**DEVELOPMENT MANAGEMENT COMMITTEE - MONDAY, 18 AUGUST
2025**

Proposal: Installation of a solar park to export up to 25 MW (AC) electricity, comprising up to 40,000no. photovoltaic panels, up to 7no. inverters & transformers, 2no. electrical buildings, 1no. onsite control building, boundary fencing and gates, security cameras, and associated infrastructure and engineering operations 25/00652/FUL

Subject: Objection - Inadequacy of Flood Risk Assessment and Surface Water Mitigation – Haddon Road Solar Park

1. Material Omission of PV Panel Runoff

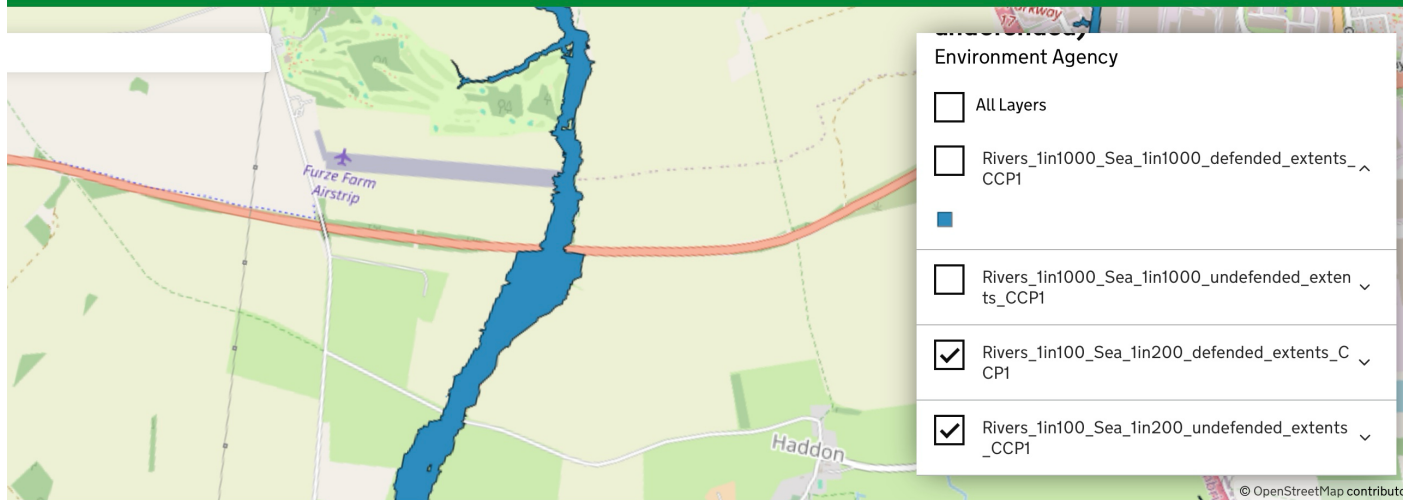
The FRA's impermeable area calculation excludes the ~100,000 m² of photovoltaic (PV) panels proposed, counting only panel supports and a handful of small buildings. This is a fundamental flaw.

PV panels shed rainfall rapidly to concentrated drip lines, producing short-duration, high-intensity overland flow, particularly on sloping sites with impeded infiltration such as the Jurassic clay and glacial till of the Northern Wolds. The omission from 40,000 PV panels leads to gross under-estimation of post-development runoff rates and required storage.

Underestimation of Runoff Volume in FRA

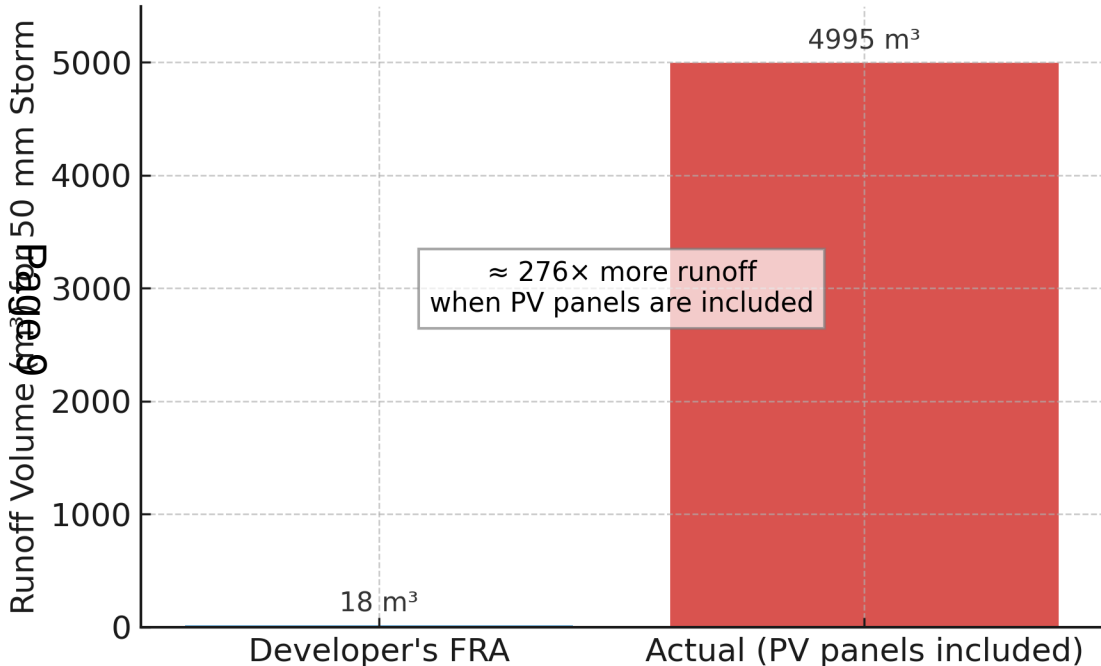
The FRA's drainage design is based on a runoff volume nearly **three orders of magnitude smaller** than the true post-development potential. This means the proposed swales are undersized by a factor of over 250, making them incapable of handling the actual storm runoff from the site.

The FRA is incomplete, based on outdated data, and underestimates the hydrological impact of the scheme. It therefore fails the NPPF requirement (para. 173) that development must be safe for its lifetime *without increasing flood risk elsewhere*.
